Re: Report No. 2
FERC Independent Consultants Review Panel
Silver Lake Dam

REPORT NO. 2
FERC INDEPENDENT CONSULTANTS REVIEW PANEL
SILVER LAKE DAM

TECHNICAL REASONS FOR THE RELEASE OF
SILVER LAKE RESERVOIR ON
MAY 14-15, 2003

Figure 2.3.1-1 Fuse plug and channel plan and profile

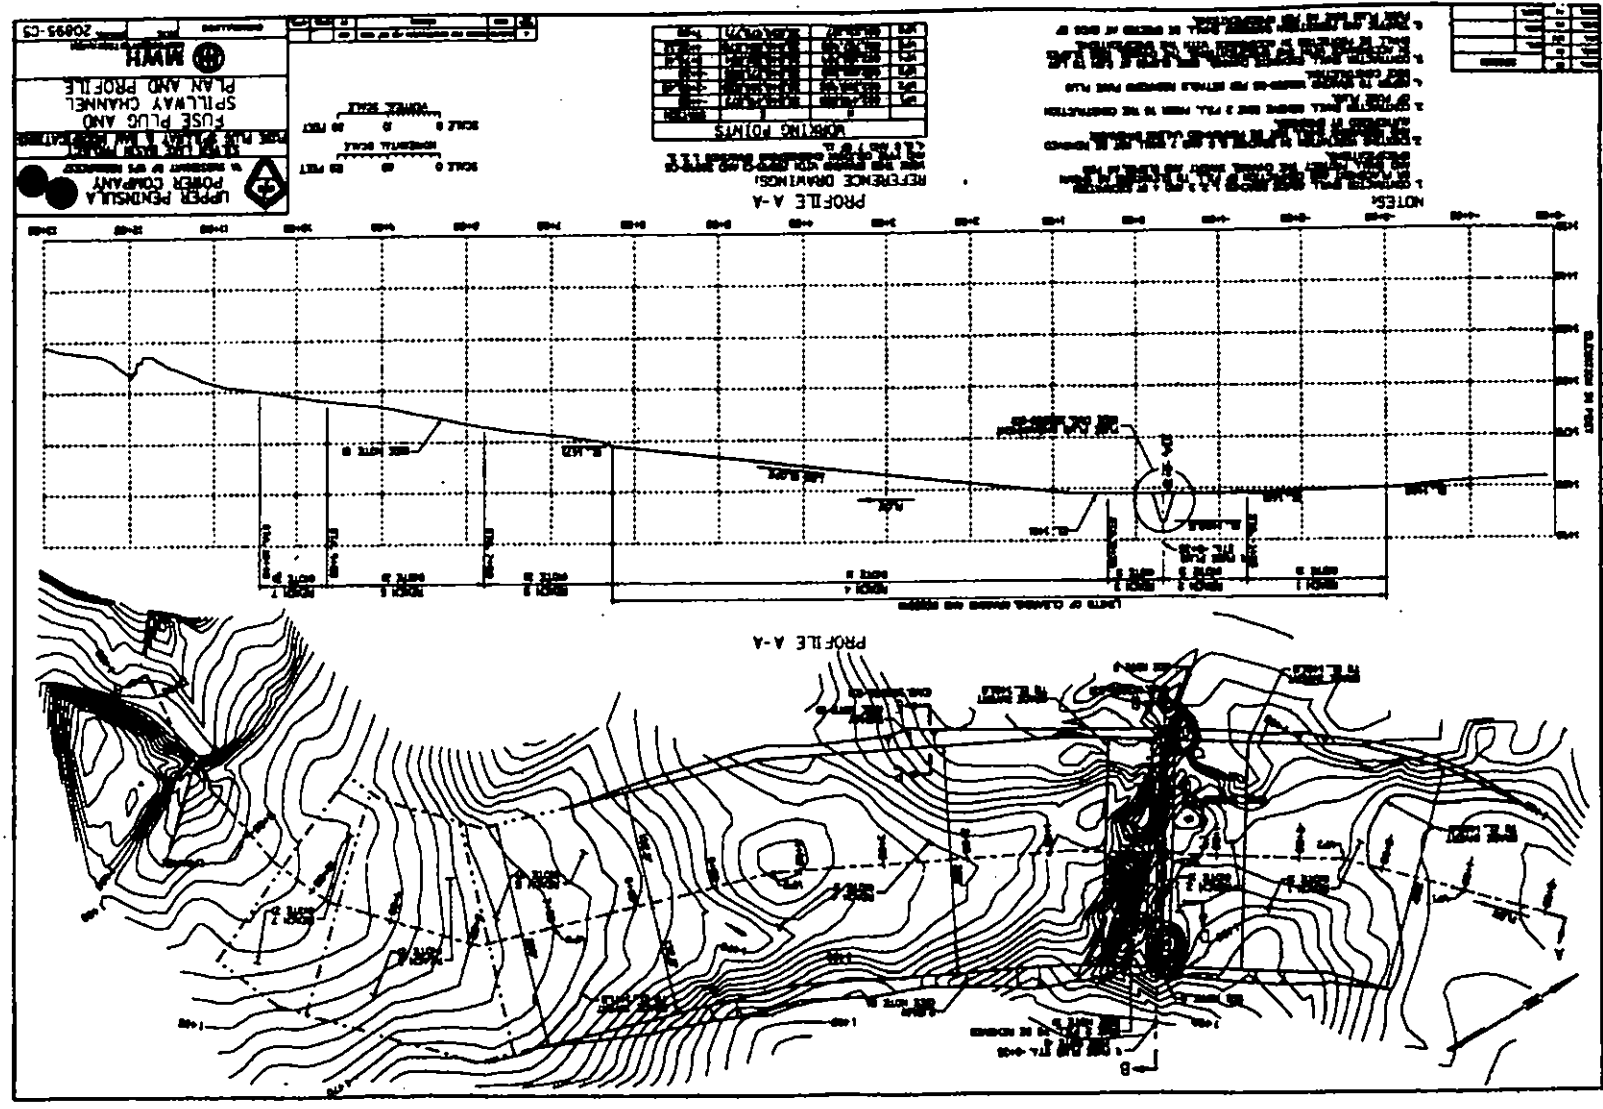
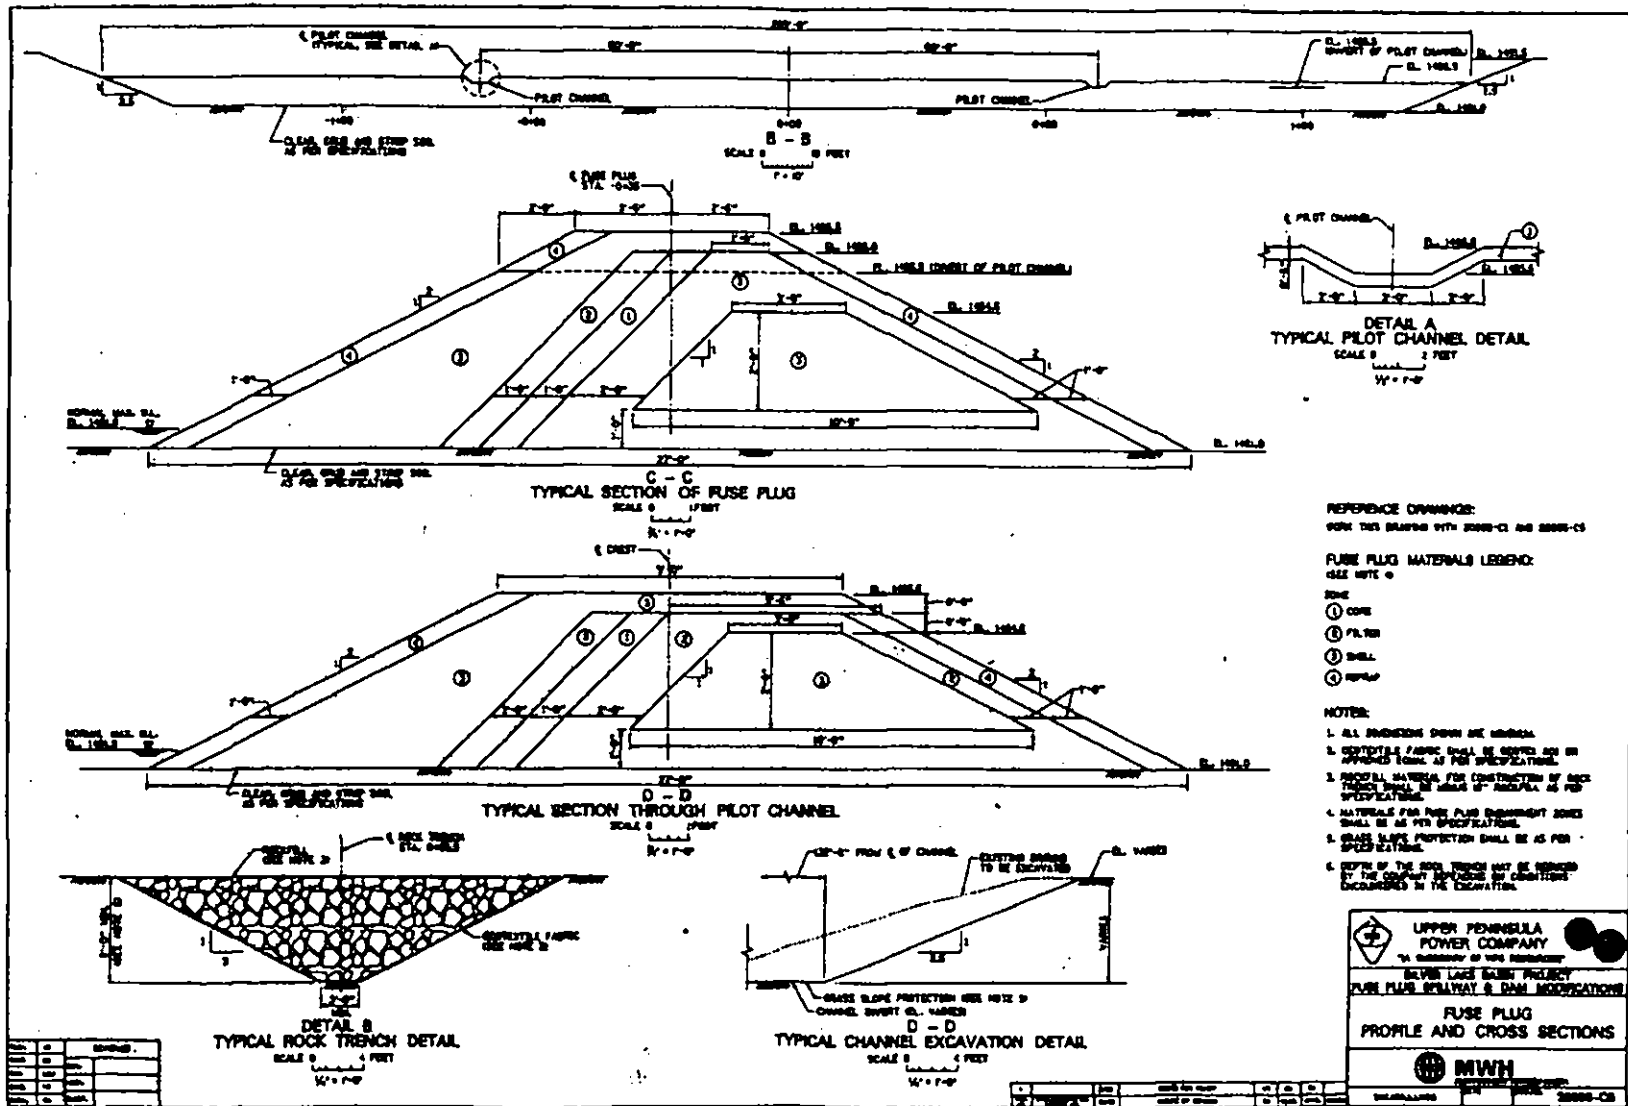
The report ignores the velocities along the outlet channel which, after a horizontal reach about 100 ft (30.5 m) long, slopes downstream at 1.8% slope for about 540 ft (165 m). The higher velocities in that portion of the channel can be inferred from Figure 8 of the Design Report "Profile Along the Emergency Spillway Channel". The flow depth at PMF conditions, which is about 8.0 ft (2.44 m) at the channel entrance, is reduced to 5 ft (1.5 m) along the 1.8% slope channel. The corresponding flow velocity is about 14.5 fps (4.4 m/s), far above the permissible velocities for grassed channels.

Even for smaller flows at the beginning of the process, the velocities on the outlet channel were bound to be higher than 6.0 or 7.5 fps (1.8 - 2.3 m/s). For the May 14, 2003 event, the breaching of the fuse plug is assumed to have occurred for water level at El. 1485.6. After the breaching, critical depth occurs at the onset of the steeper channel downstream from the fuse plug. At the initial stages, after washing out of the fuse plug, head losses in the horizontal channel add to the control and restrict the discharge over the wide channel to about 5000 cfs (142 m³/s). Critical velocity reaches about 8.5 fps (2.6 m/s).

The maximum velocities in the fuse plug channel were underestimated. Grass cover would not provide adequate protection against erosion.

Figure 2.3.2-4

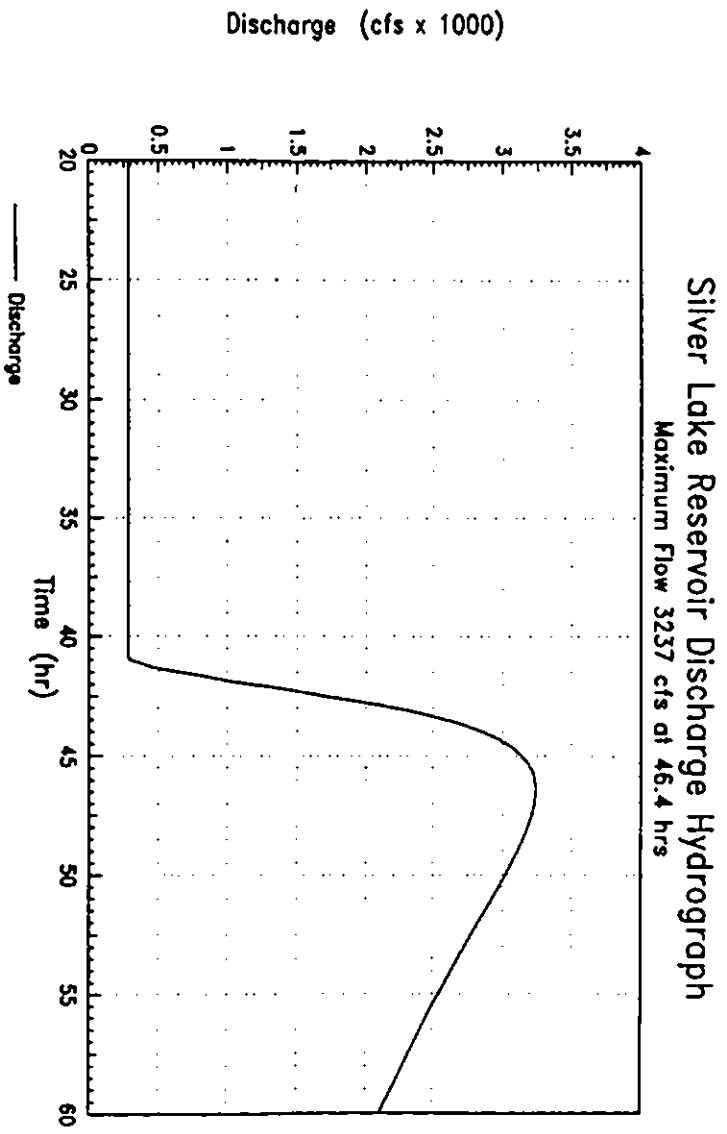
The Panel requested the Chicago FERC office to do a calculation for the PMF hydrograph inflow shown in Figure 2.2-1 routed through the Silver Lake reservoir for an initial reservoir elevation of 1481.5 and considering the low level outlet to operate at 280 cfs (8 m³/s) starting 20 hours into the inflow hydrograph. It was assumed that all bays in the concrete spillway, including the stop logs in the 4th bay, had an ogee elevation of 1486.25. It was found that the maximum reservoir level raised to 1490.5 ft [a freeboard of about 1.0 ft (.3 m)]. The hydrograph of the reservoir elevation and spillway discharge versus time is shown in Figure 2.3.2-5. It is noted that the reservoir elevation is shown to be above 1490 ft for about 8 hrs.

The maximum discharge for this case (Figure 2.3.2-5) is only 3237 cfs (92 m³/s) as compared to the 20,000 cfs (568 m³/s) discharge in the selected fuse plug design. Raising of all embankments to 1491.5 and operating the reservoir to 1481.5 as an initial condition would allow the PMF to be accommodated by use of the original spillway with no fuse plug construction. This concept has the advantage that the key elevations of all structures are equal to or higher than the "old" structures which have accommodated many significant floods since they were constructed in 1944, enhancing the safety for more frequent floods.

Figure 3.6.2-3 Water levels in Silver Lake before and after fuse plug breach

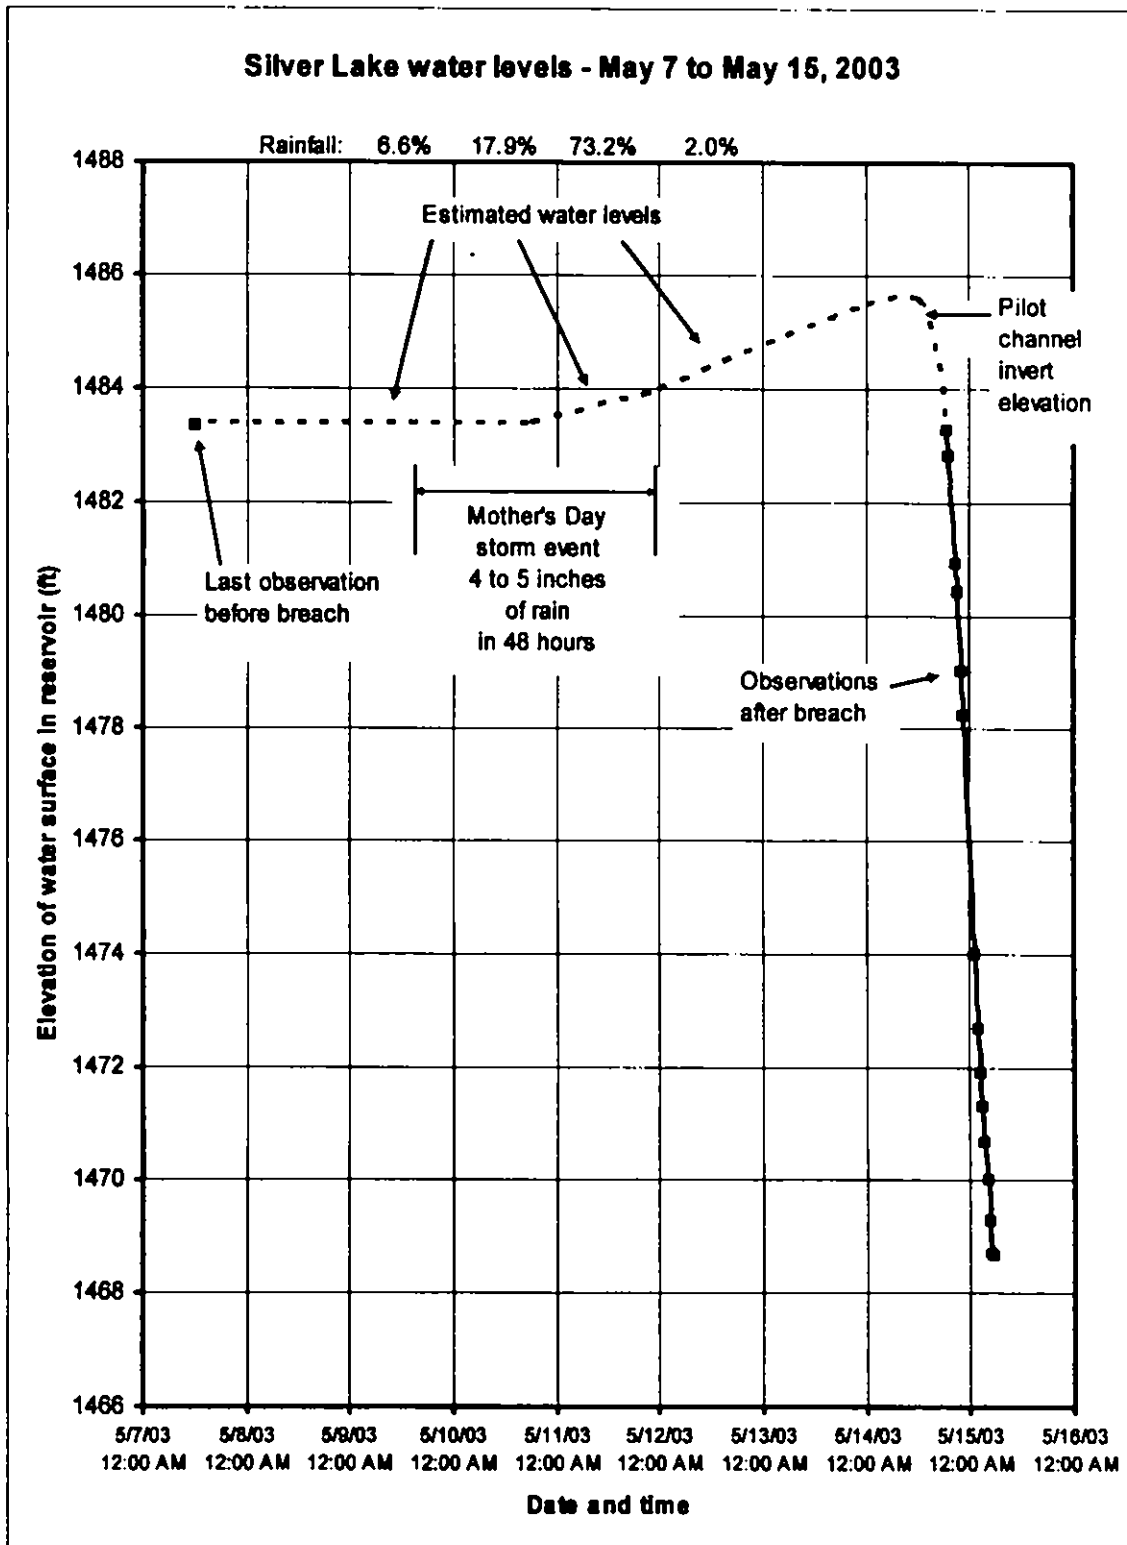
Although the maximum water level, and the time at which it was reached, cannot be determined with precision, the facts available have been used to develop the graph of estimated Silver Lake water levels from May 7 to May 15 shown in Figure 3.6.2-3. The estimated water levels between May 7 and May 14 are based on the assumptions that the lake level would be about constant until the Mother's Day storm event, and that the resulting inflow was the principal cause of the rise in lake level, and that the maximum lake level corresponds to the high water mark indicated by the debris trapped at the ends of the stop logs. While there is some uncertainty about the variation of water level with time

shown in Figure 3.6.2-3, the variation shown is consistent with the available information.

Figure 3.6.4-2 Cross section through eroded channel at STS Station 27+00, near fuse plug axis

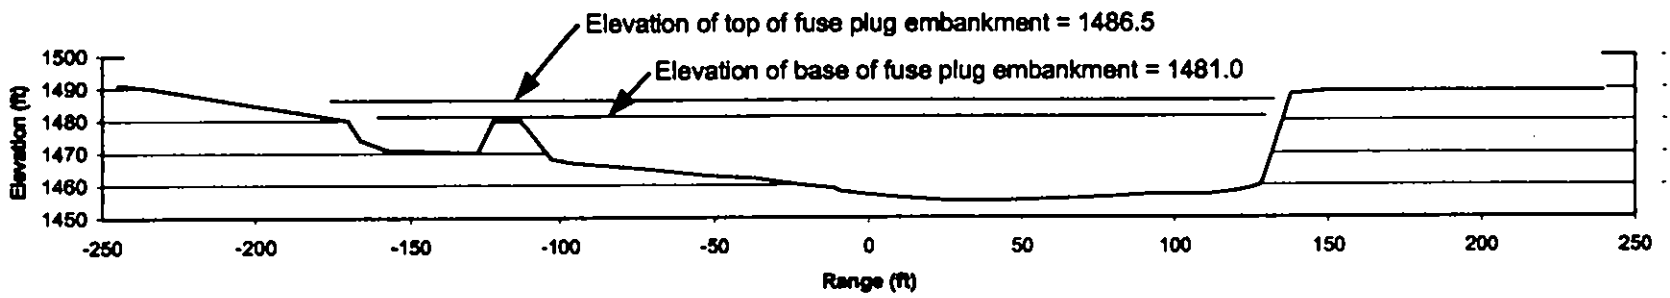
Figure 3.6.4-2 shows a cross section at STS station 27+00, approximately at the axis of the fuse plug embankment. The eroded channel is about 300 ft (91.5 m) wide, extending 130 ft (39.6 m) to the right of the STS stationing axis, and 170 ft (51.8 m) to the left. An un-eroded "island" about 120 ft (36.6 m) to the left of the station axis indicates that the course of erosion was governed to some extent by non-uniform resistance to backcutting as the eroded channel became progressively wider and deeper.
